# Transmitter Characteristics (83D.3.1)

Ryan Latchman, Mindspeed

# Transmit equalizer

# Transmit equalization characterization

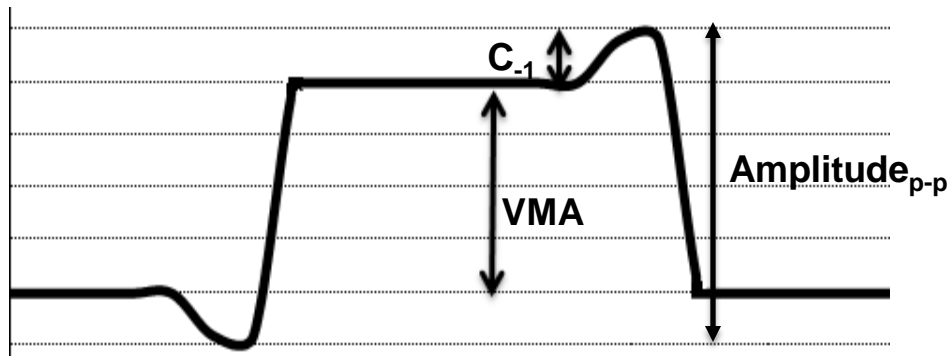
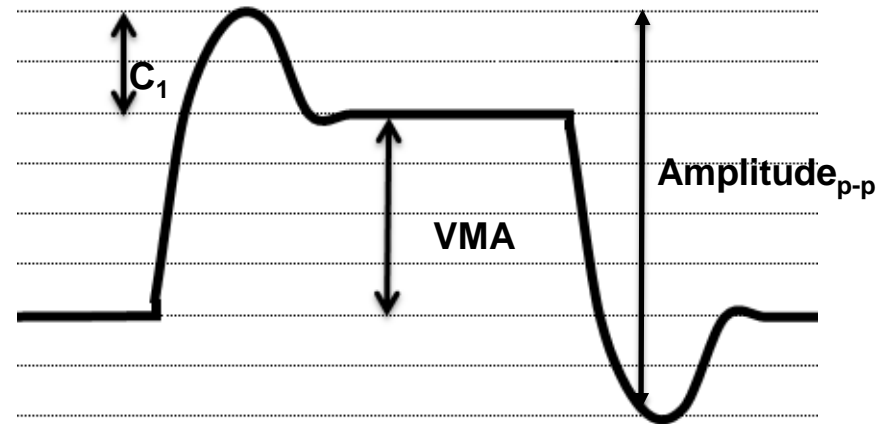
**Minimum transmit equalizer range:  
Change TBD to tables shown on right**

- **Transmitter equalizer range**
- The CAUI-4 chip-to-chip transmitter includes programmable equalization to compensate for the frequency-dependent loss of the channel and to facilitate data recovery at the receiver. The functional model for the transmit equalizer is the three tap transversal filter shown in TBD. The minimum pre cursor equalization (c(-1)) supported is shown in table TBD.

- The minimum post cursor equalization (c(1)) support is shown in table TBD

- The transmitter output equalization is characterized using the procedure described in TBD.

Pre Cursor Equalizer Setting	Pre Cursor Equalization Value
1	0dB +/- 1dB
2	1.5dB +/- 1dB
3	3dB +/- 1dB

Post Cursor Equalizer Setting	Post Cursor Equalization Value
1	0dB +/- 1dB
2	2dB +/- 1dB
3	4dB +/- 1dB
4	6dB +/- 1dB

- Measure VMA per 86A.5.3.5 using square wave or PRBS9 defined in Table 86-11 using a test system with a fourth-order Bessel-Thomson low-pass response with 33 GHz 3 dB bandwidth
- Set post-cursor equalization to the zero setting. Measure pre-cursor amplitude defined as the peak amplitude before a transition. Define  $C_0$ ,  $C_{-1}$  as normalized main tap, and pre-cursor values per equations A and B. Calculate pre-cursor value for each pre-cursor setting using equation C
- Set pre cursor equalization to the zero setting. Measure post-cursor amplitude defined as the peak amplitude after a transition. Define  $C_0$ ,  $C_1$  as normalized main tap, and post-cursor values per equations D and E. Calculate post-cursor value for each post-cursor setting using equation F

Equation A  $|C_0| = 1 - |C_{-1}|$

Equation B  $|C_{-1}| = |C_0| - \frac{VMA}{Amplitude_{p-p}}$

Equation C  $Pr\ cursor\_value = 20 * LOG10\left(\frac{1}{C_0 - C_{-1}}\right)$

Equation D  $|C_0| = 1 - |C_1|$

Equation E  $|C_1| = |C_0| - \frac{VMA}{Amplitude_{p-p}}$

Equation F  $Pr\ cursor\_value = 20 * LOG10\left(\frac{1}{C_0 - C_1}\right)$

Figure 83D-7—Transmitter eye mask

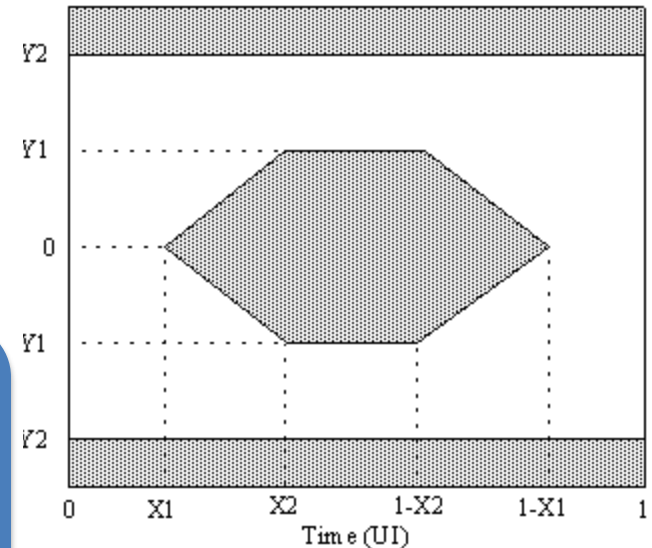
- The eye mask shown in is defined at a BER of  $10^{-15}$ , using the methodology described in TBD. Transmitter equalizer may be adjusted for optimum mask results.

- The transmit output waveform in CAUI-4 chip-to-chip is measured using a fourth-order Bessel-Thomson low-pass filter response with 33 GHz 3 dB bandwidth. Compliance with X1 is verified using the methodology described in 83D.3.1.4 where the maximum TJ is  $2 \times X1$ . Compliance with Y2 is verified using the methodology described in 83D.3.1.1. Compliance with Y1 is verified using the following procedure with a PRBS9 waveform:

- Capture the PRBS9 pattern using a clock recovery unit with 3 dB tracking bandwidth of 10 MHz and maximum peaking of 0.1 dB and a minimum sampling rate of 3 samples per bit. Collect sufficient samples equivalent to at least 4 million bits to allow for construction of a normalized cumulative distribution function (CDF) to a probability of  $10^{-6}$  without extrapolation.

- Use the differential signal from step 1 to construct the CDF of the signal amplitude at X2, midpoint (0.5) and  $1-X2$ , for both logic 1 (CDF1) and logic 0 (CDF0), as a distance from the center of the eye. Calculate the eye height for each point (EH6) as the difference in amplitude between CDF1 and CDF0 with a value of  $10^{-6}$ . CDF0 and CDF1 are calculated as the cumulative sum of histograms of the amplitude at the top and bottom of the eye normalized by the total number of sampled bits. For a well balanced number of ones and zeros the maximum value for CDF0 and CDF1 will be 0.5.

- Apply the Dual-Dirac and tail fitting techniques to CDF1 and CDF0 to estimate the noise at X2, 0.5 and  $1-X2$  points. Calculate the best linear fit in Q-scale over the range of probabilities of  $10^{-4}$  and  $10^{-6}$  of CDF1 and CDF0 to yield relative noise one (RN1) and relative noise zero (RN0). The eye height for plotting against the eye mask at X2, 0.5, and  $1-X2$  is then given by

- $EH15 = EH6 - 3.19 \times (RN0 + RN1)$
- where
  - *EH15 peak* is the eye height extrapolated to  $10^{-15}$  probability
  - *EH6* is the eye height at  $10^{-6}$  probability
